**STATE OF HAWAII
DEPARTMENT OF LAND AND NATURAL RESOURCES
OFFICE OF CONSERVATION AND COASTAL LANDS
Honolulu, Hawaii**

REGARDING: Conservation District Use Application (CDUA) OA-3297
for the Duke Kahanamoku Lagoon Restoration Project

APPLICANT: Hilton Hawaiian Village, LLC (HHV)

LOCATION: Waikiki, Island of Oahu

Figure 2-4:

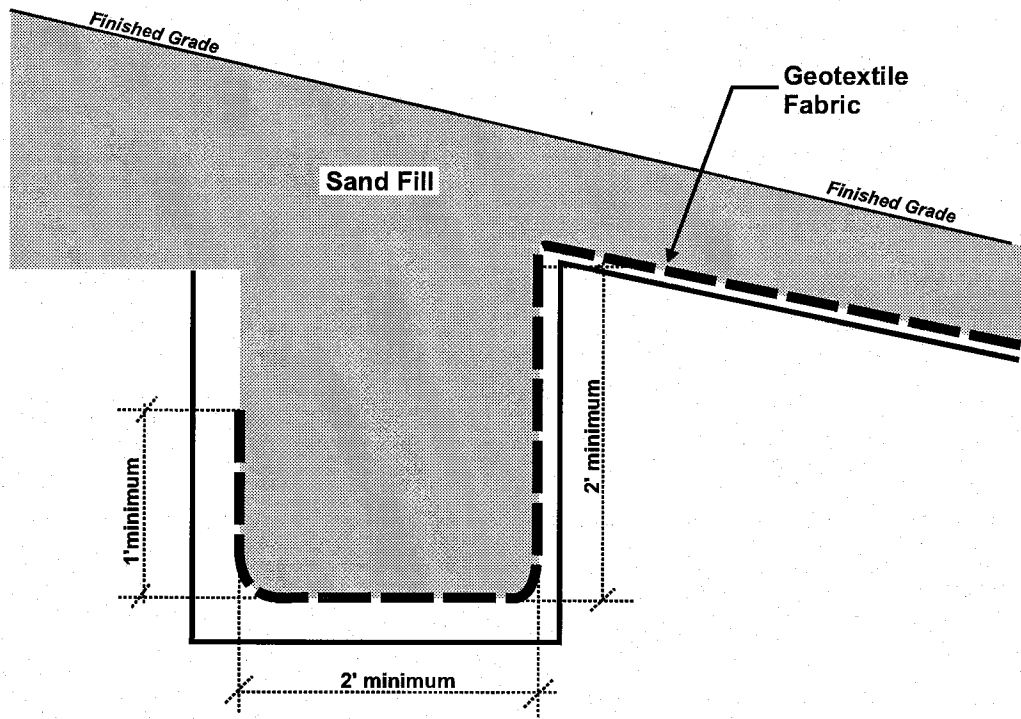
DAR is concerned whether the anchoring system for the material is sufficient to keep it in place during rough ocean conditions. If the fabric separates, the soft sediment will mix with the sand overlay compromising the water quality in the lagoon.

HHC plans to reinforce the existing shoreline berm in order to prevent the geotextile fabric layer from loosening when waves overtop the berm during large storm events. This will be done by emplacing an armor-stone structure beneath the existing berm and using it to anchor the geotextile fabric.

Specifications for the geotextile liner have been made in HHC's Request for Proposals for the lagoon restoration. The proposed design calls for the geotextile fabric to be secured around the perimeter. Conceptual designs for anchoring are presented. The buried stone reinforcement that is planned under the existing beach berm on the seaward side of the lagoon would prevent the berm from washing away, and any water that comes
